SERVICE BULLETIN

RB397

RB397-MK2

April 1, 2012

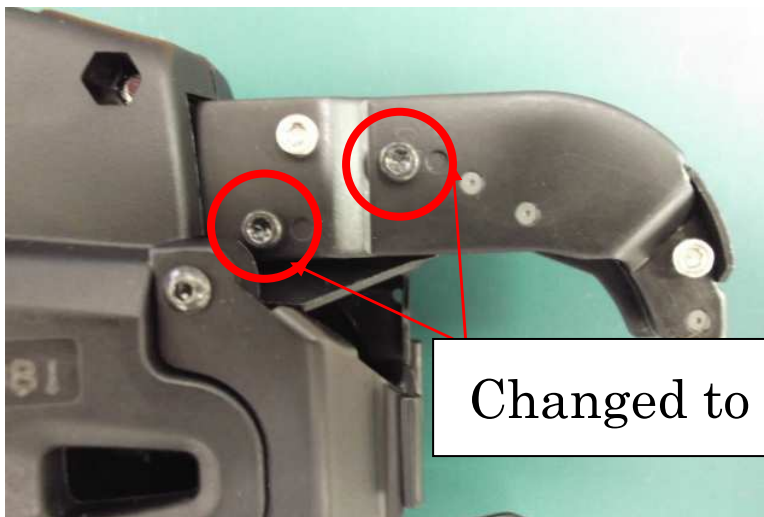
When clean up at the cutter area is required, service person should unscrew the chrome color bolts only and should not unscrew the black bolts on the Arm Cover. In order to secure this, 2 pcs of Black Hex bolt M3x5 (BB40711) were changed Torx bolt M3x5(BB86701).

Old Hex bolt BB40711 was discontinued.

Changed to Torx Type
